**PRELIMINARY DRAINAGE REPORT
FOR
~~EARLY GRADING PERMIT APPLICATION~~
PCD FILE NO. EGP-20-002**

MOUNTAIN VIEW ACADEMY
TRACT H, CLAREMONT RANCH, FILING NO. 4
EL PASO COUNTY, COLORADO

February 07, 2020
Rev. April 05, 2020

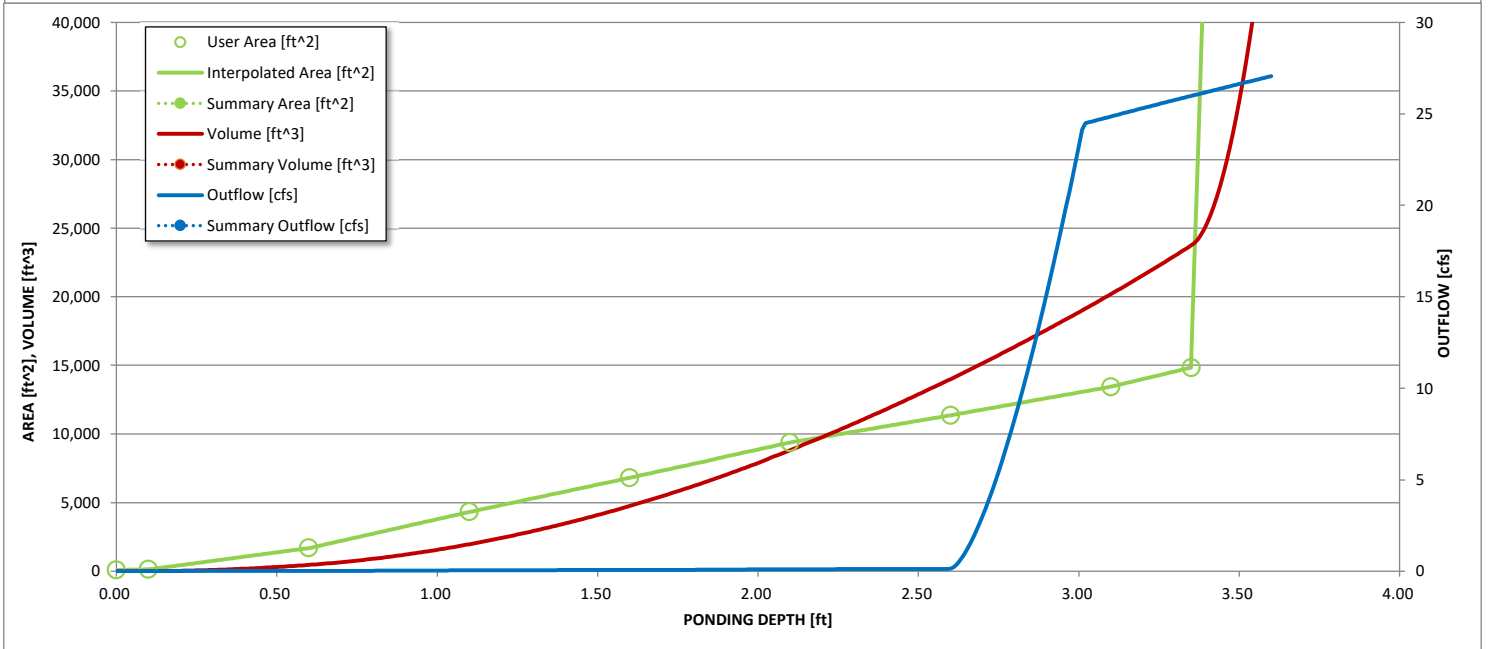
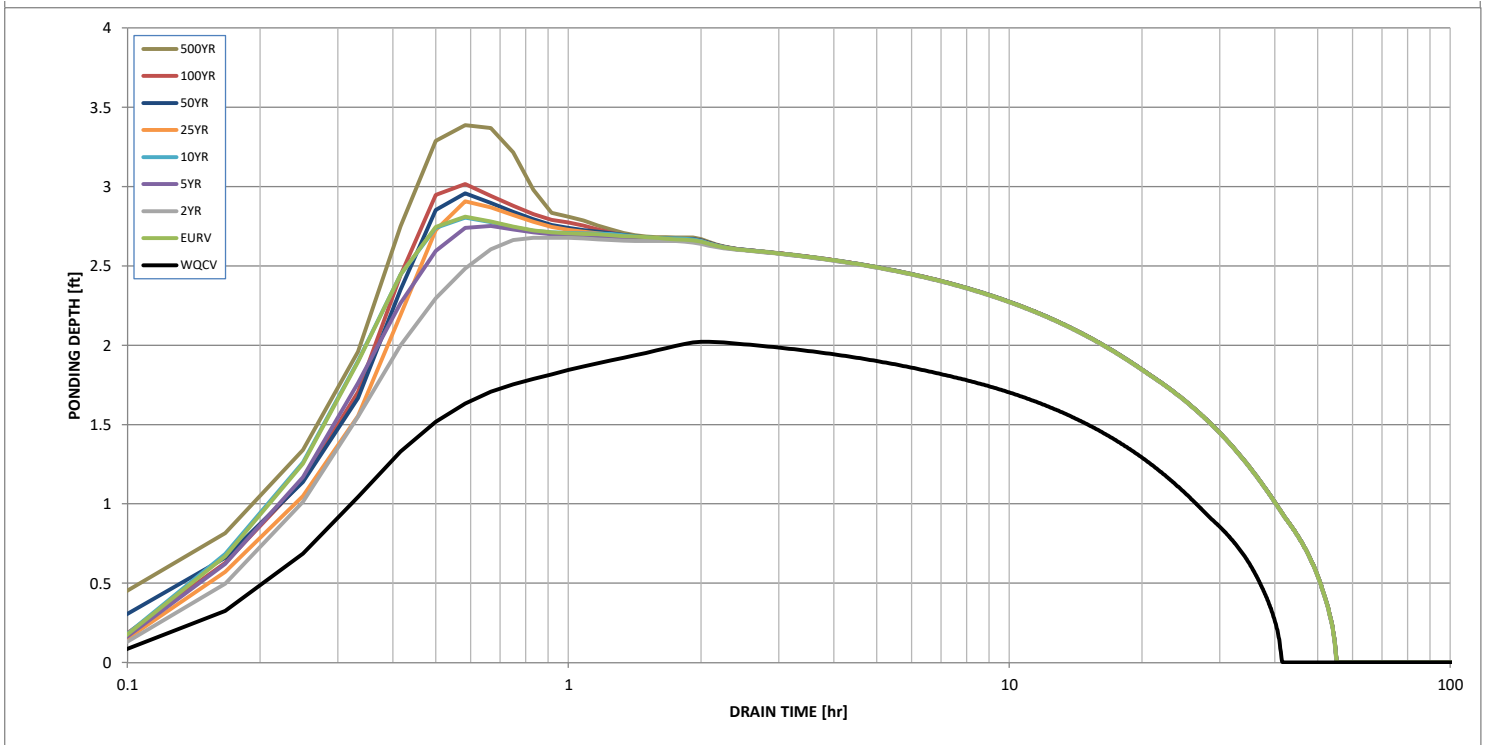
Provide over detention as described in approved deviation letter. In this case, tributary imp % = 76% was applied to the entire site.
